Site no H794 Dunbotle lane Site address Flash Lane, Mirfield Application number 2017/60/94124/E

Mirfield Town Council Comments

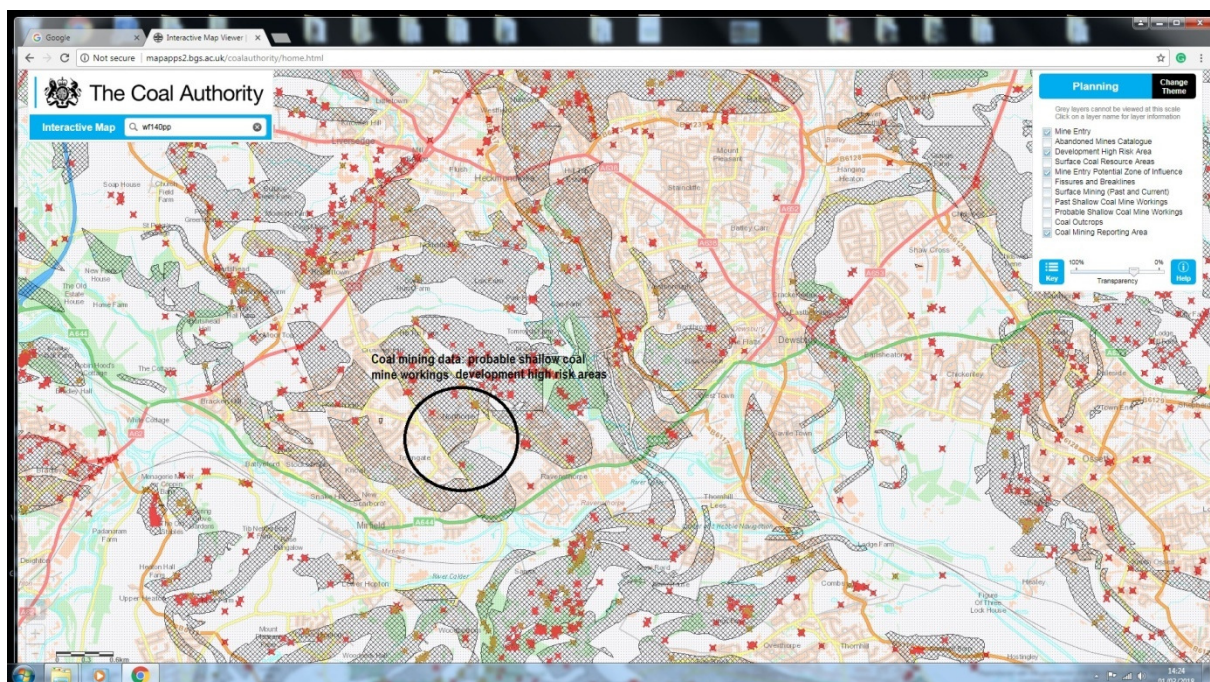
The site also conflicts with surface water flood maps that show a linear pattern (depression) flow route where houses are to be located. more information is required to demonstrate that there is a commitment to ensure houses are protected from such events and overland flows, and it is feasible that water from the highway will not enter curtilage in the final promoted design and adjacent existing property's downstream. Flood routing should not terminate with-in 150m of any existing low level properties under ground nor over ground.

I would advise land drainage protection will be required for the properties located at lower levels from landscaped areas that could generate runoff from saturated land.

LOW RISK OF SURFACE WATER FLOODING

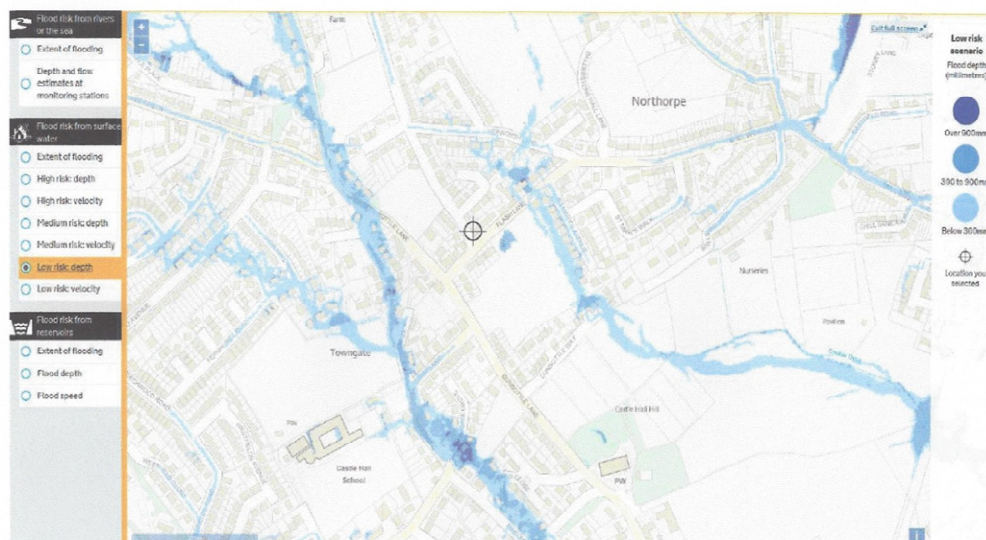
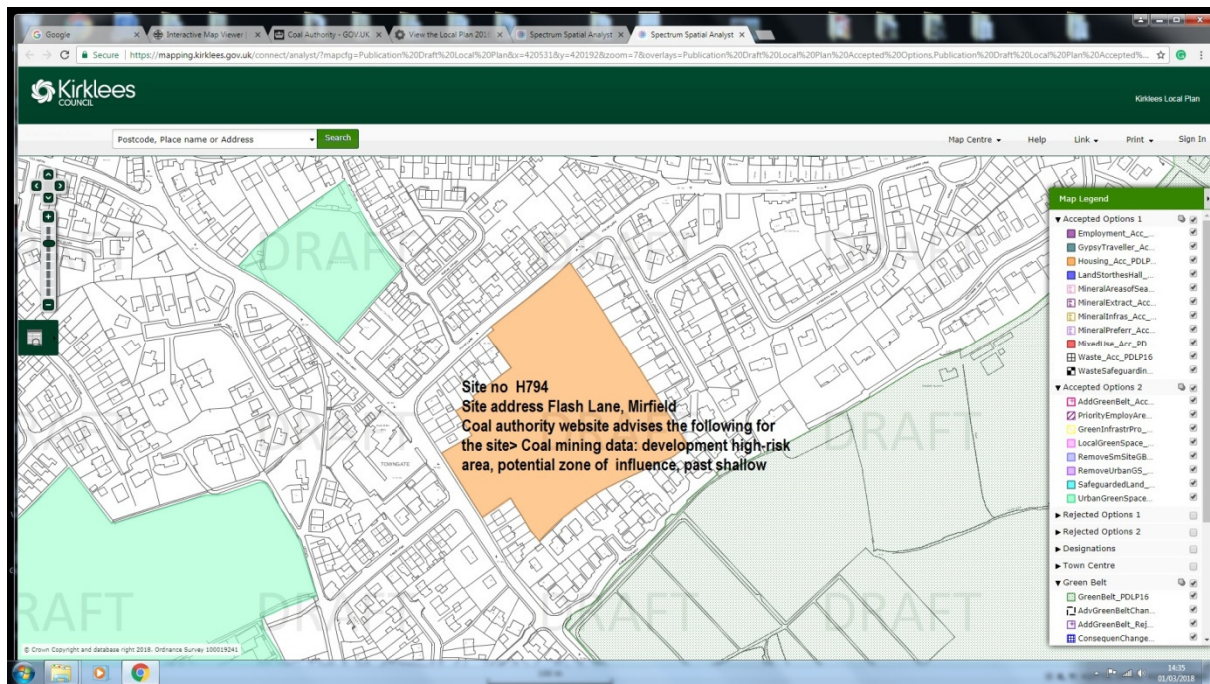
Mitigation proposals should be stated. Temporary Drainage Strategy Protection of existing properties during the construction phase post soil and vegetation strip will be required as increased runoff is envisaged on this sloping site.
